December 5, 2024

BYTEK VW Expansion Project
1325 St. Laurent Blvd.
Ottawa, Ontario
Our Ref: 2301

Addendum N° 5

Fire Door 7301 Elevation Data Sheet

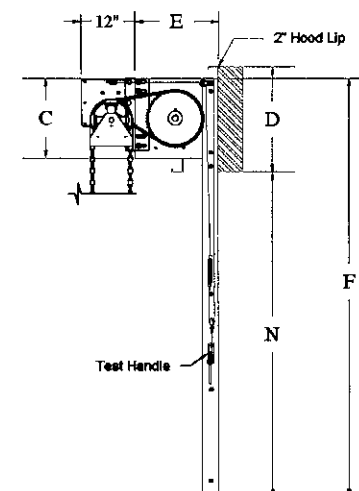
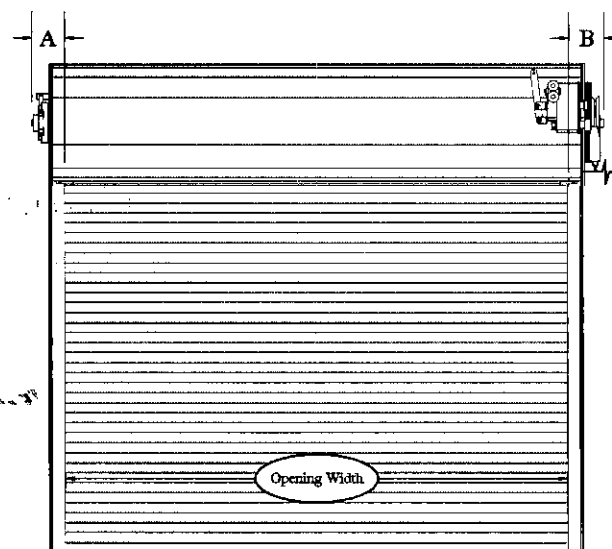
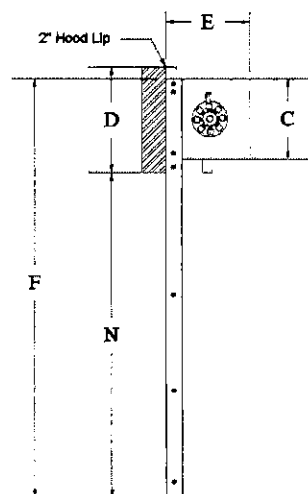
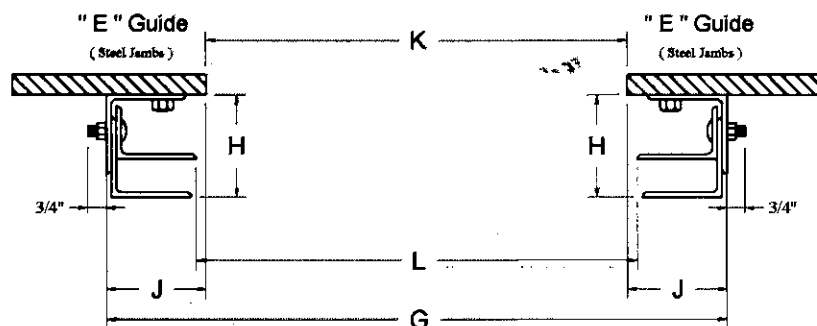
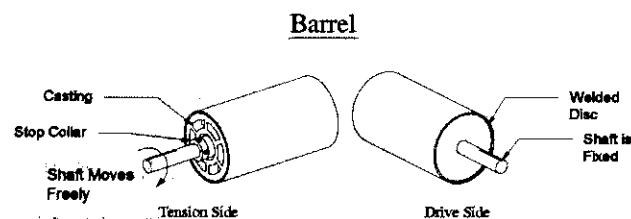
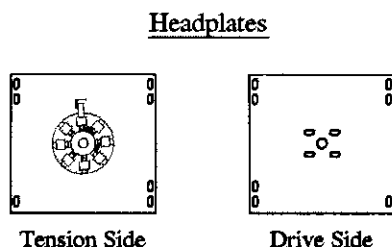
1.9.2 Fire Shutters C.H.I. Fire Shutters model 7301 to be used. Refer to attached Data Sheet.

1 SITE PLAN
A001 SCALE 1:200

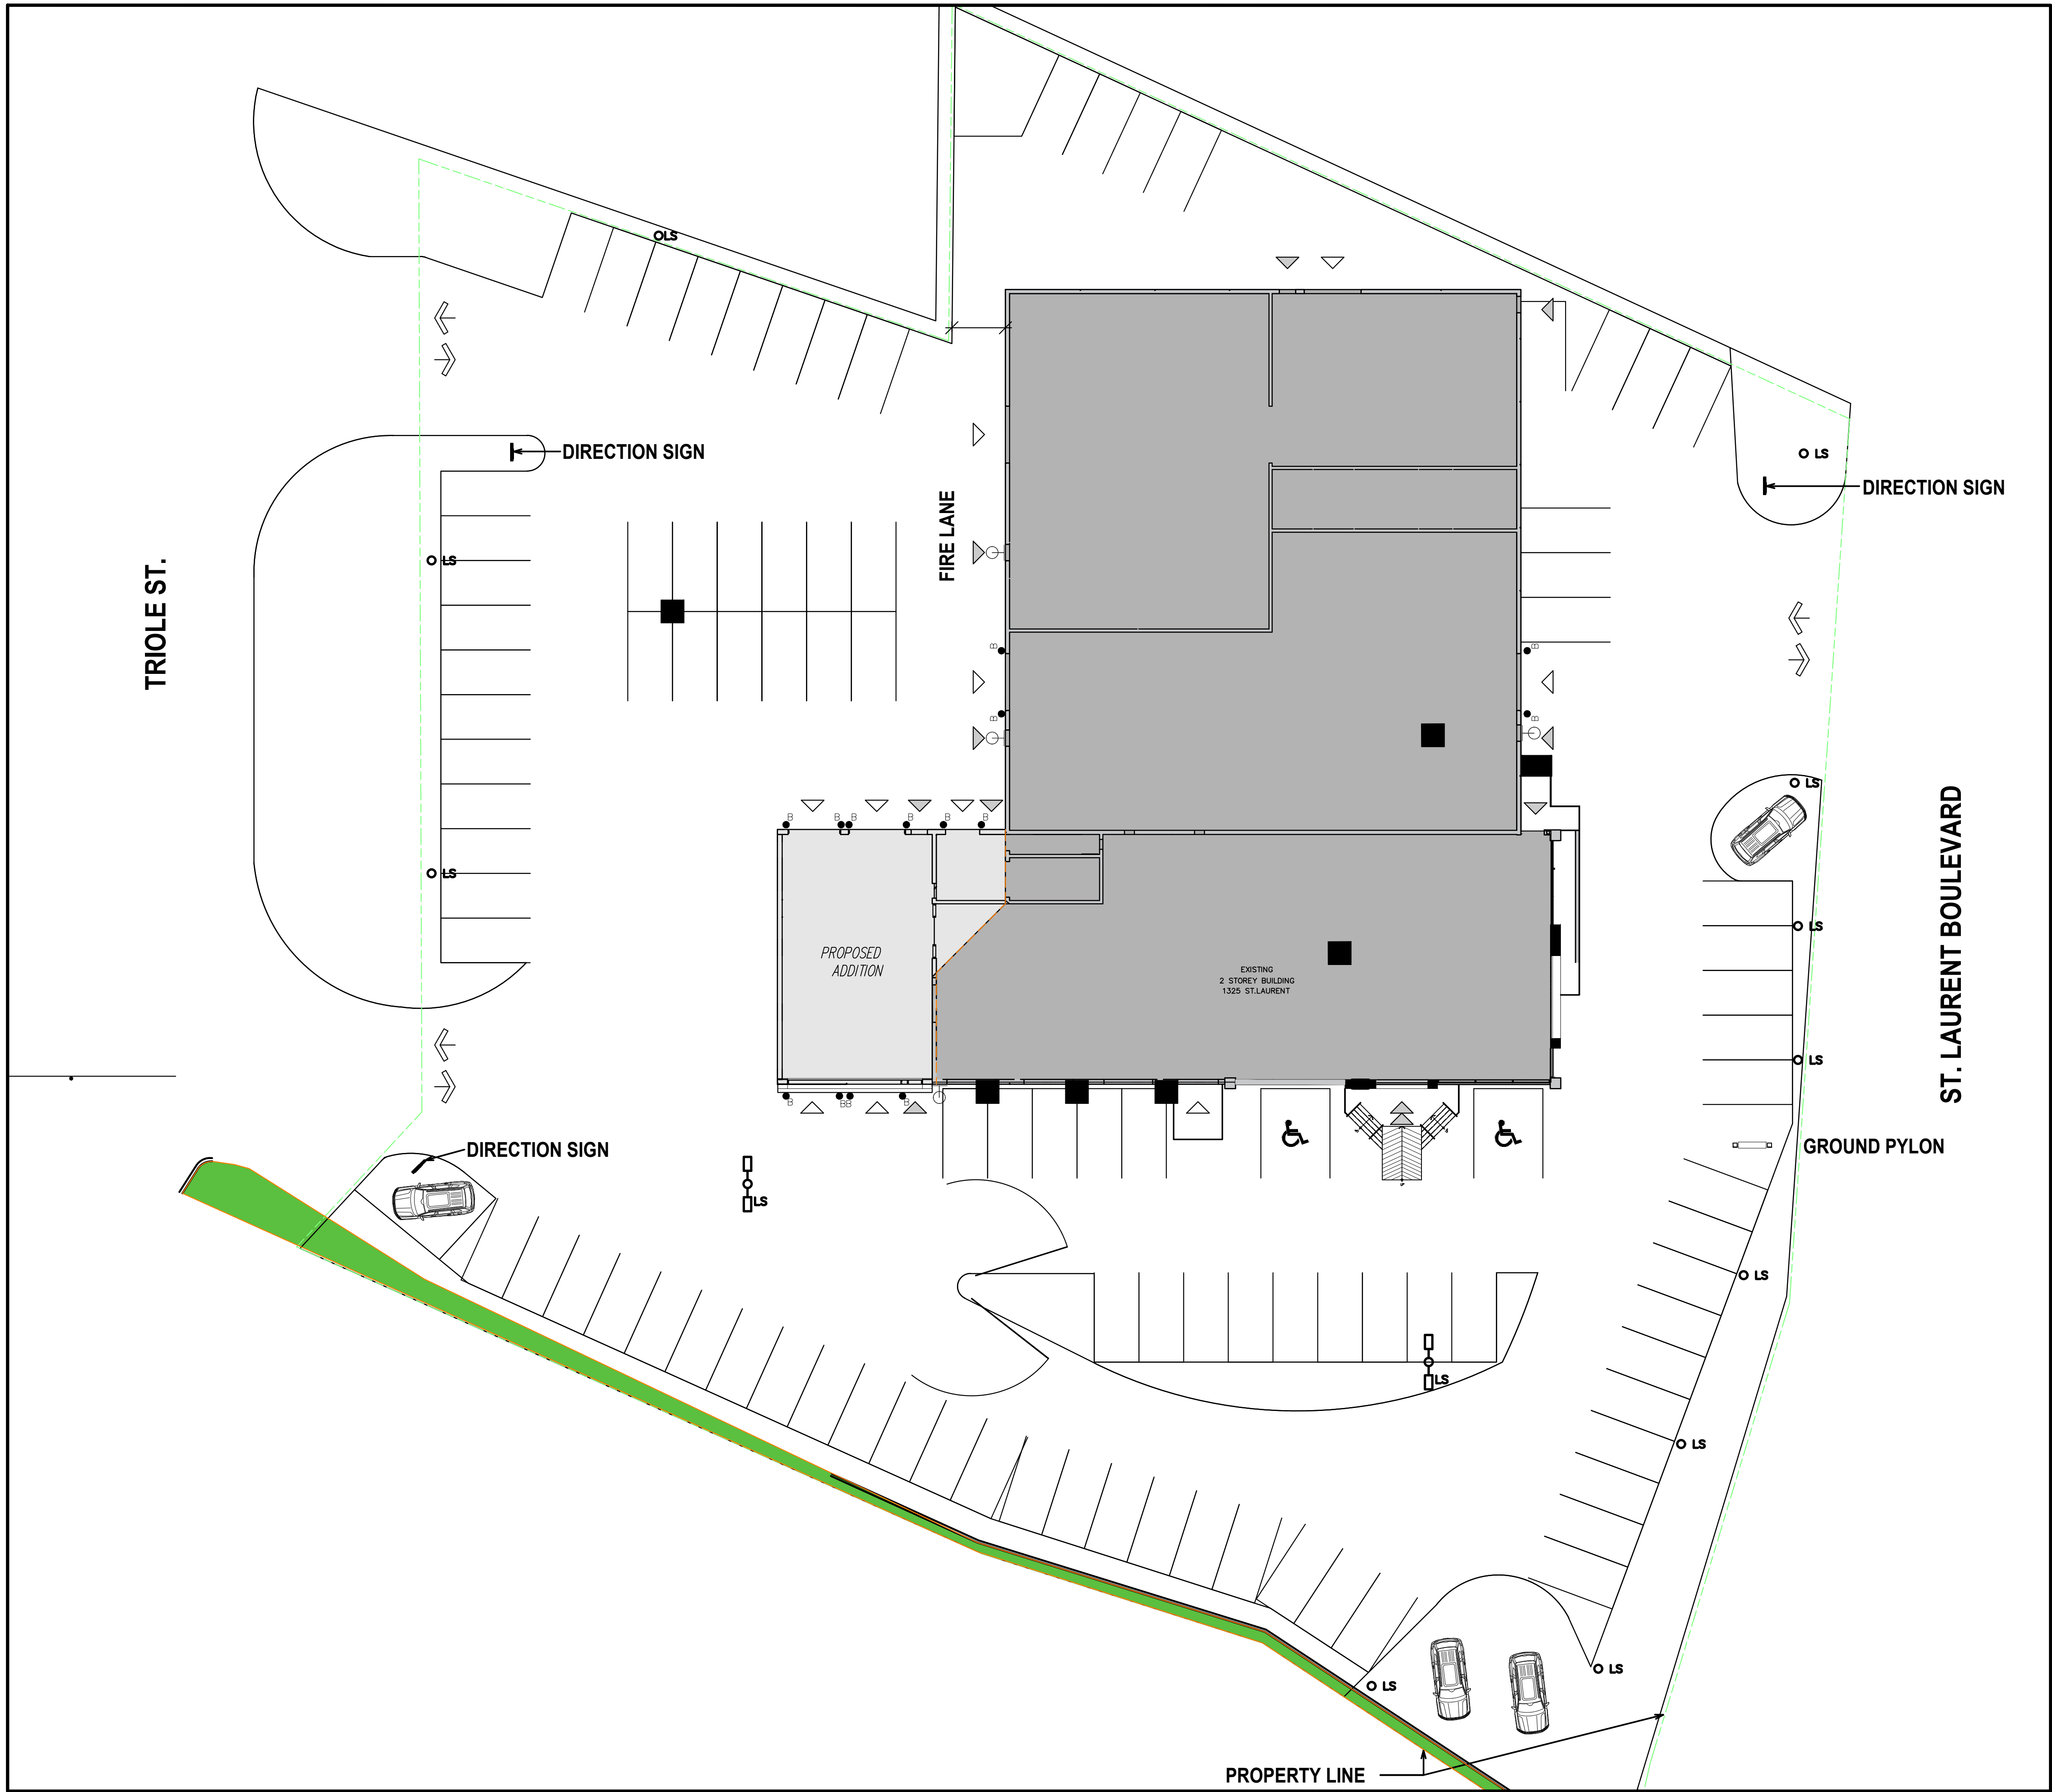
- 1.2 Reference drawings A-201, Elevations, Revised
 - 1.2.1 Signage and lighting.
 - 1.2.2 Elevations revised to reflect size of floor plan.
- 1.3 Reference drawings A-001, Site Plan, Revised

- 1.3.1 Pole and existing lighting.
 - 1.3.2 Existing barrier free ramp to be refinished. Colour grey.
 - 1.3.3 Supply and install 14 (fourteen) concrete filled galvanized steel bollards. Final location to be determined by Owner.

DRAWING
**SCHEDULE
PARTITIONS**

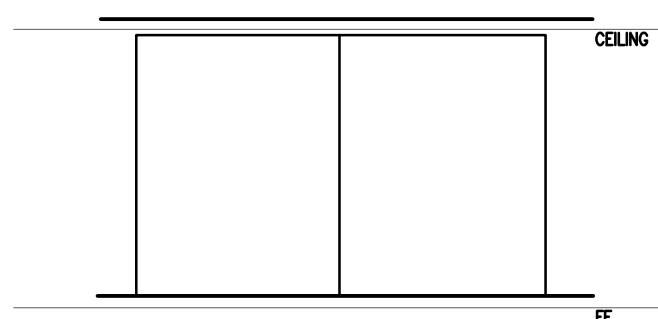
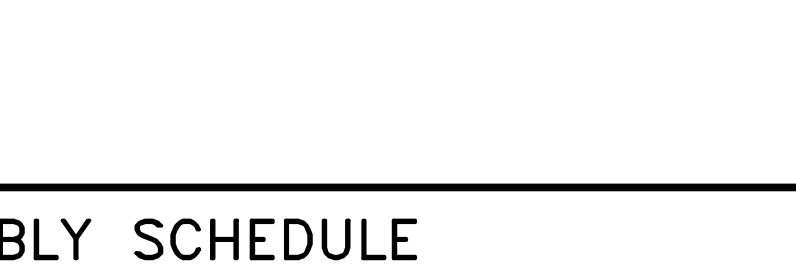
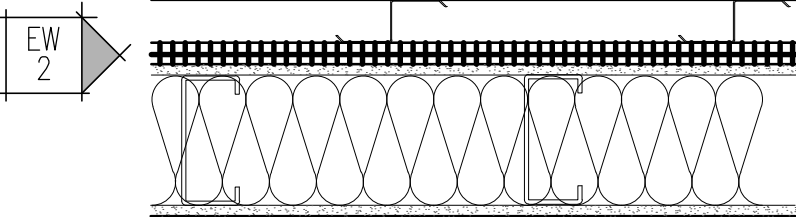
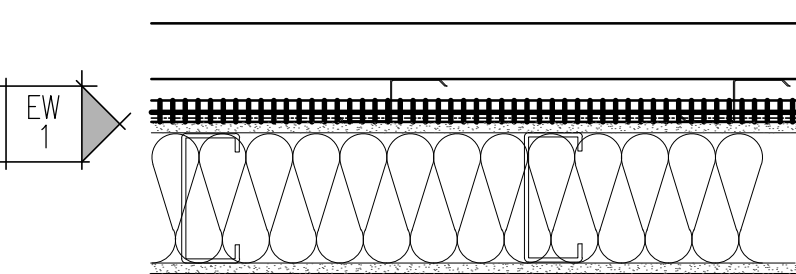
- 1.4.3 Add plywood backing for all new electrical as required. Refer to electrical.
- 1.5 Reference drawings A-100, Schedule Partitions, Revised
 - 1.5.1 Revise partition assemblies numbering PW-4 to PW-5.

- 1.5.2 Revise partition assemblies numbering PW-5 to PW-6.

- 1.5.3 Add new PW-5 for a 152mm stud wall.
- 1.5.4 Add new floor assembly type F5 for a 1 HR. UL Des. No. D799, 1 HR fire resistant rating, provide spray applied fire proofing as required.

- 1.5.5 Apply intumescent paint to all new structural columns to meet a 1HR rating. UL Des. No. Y616, 1 HR rating. Thickness of coating as required.
- 1.6 Reference drawings A-101, Basement Plan, A-102 Ground Floor Plan, A-103, Mezzanine Plan and Roof Plan, Revised
